UCID-18138

TECHNICAL EVALUATION OF THE
ALTERNATE TO THE KEYLOCK CONTROL TO THE BYPASS VALVES
FOR THE DAVIS-BESSE NUCLEAR POWER PLANT, UNIT 1

Jose G. Ibarra

September 1979

Figure 1. DHR Suction Line Diagram.

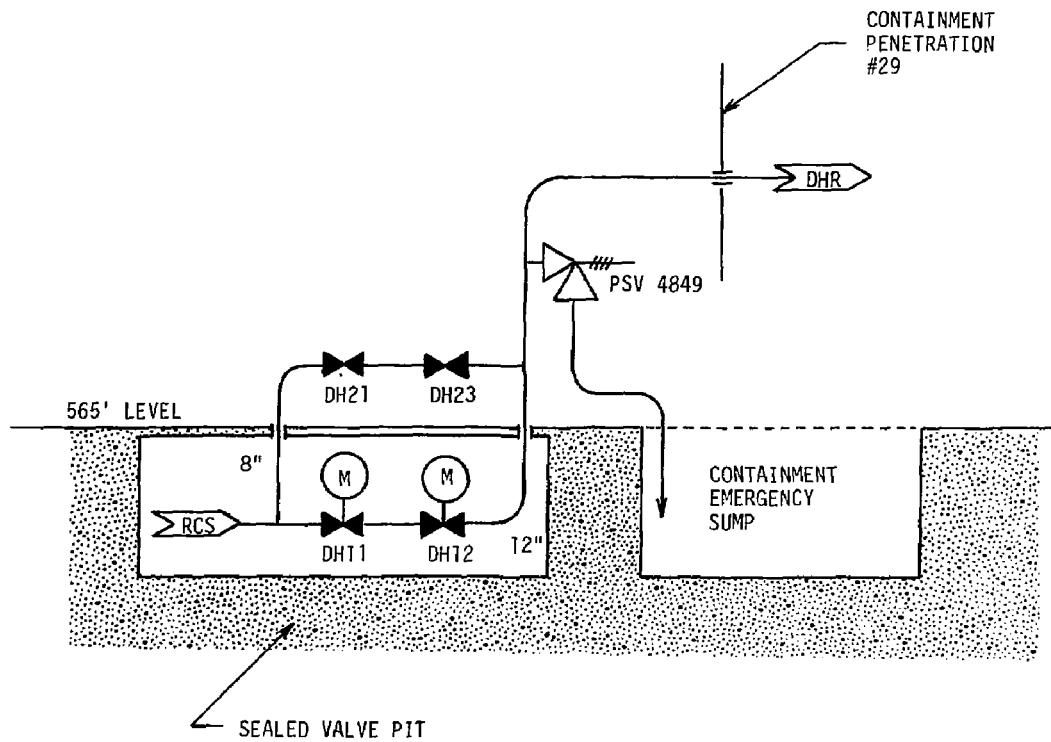
The bypass loop contains two manually operated valves around the DHR suction line valves. The two manual isolation valves are in series on the bypass line. The normally closed bypass valves would be opened in the event of a spurious closure of one of the DHR system suction line isolation valves during system operation. The NRC requires that

Present control procedures utilize a chain and padlock. The padlock key opens no other valves, but it does open certain restricted-area doors.

The results and conclusions for the frequency of DHR overpressure incidents are presented. The dominant problem is maintenance on the pressure relief valve (PSV 4849) which is located on the DHR suction line downstream of the tee at which the bypass line rejoins the principal DHR

suction line. The relief valve must be removed occasionally for bench testing, and it is possible for the maintenance personnel to inadvertently open the bypass after reinstalling the pressure relief valve. Maintenance on PSV 4849 can only be performed while the reactor coolant system (RCS) is between hot shutdown and cold shutdown. Therefore, the risk of exposing the DHR system to damaging overpressure or of initiating a severe interfacing-systems LOCA is much less than for accident sequences applicable to periods of power generation.

The TECO technical report³ concludes that the present design and procedures for Davis-Besse nuclear power plant, Unit 1, offer sufficient protection for the health and safety of the public. However, the present design and procedures do not meet the criterion inferred from the Reactor Safety Study (WASH-1400)⁴ that the accident sequence fails to meet the criterion associated with shutdown when the risk is much reduced. In order to improve safety and meet the inferred acceptance criterion without question, TECO is prepared to implement Procedural Option (c), proposed in Section 2.2, which will require the use of one unique key and lock to secure the bypass valves.

We conclude that the TECO technical report³ fulfills the NRC SER¹ requirements for an analysis of the design modification alternatives for the present keylock control of the manual bypass valves (DH21 and DH23) for Davis-Besse nuclear power plant, Unit 1. The licensee's proposed procedural change requiring the use of one unique key and lock to secure the bypass valves decreases the likelihood of the bypass being opened inadvertently when isolation of the DHR system loop is required.
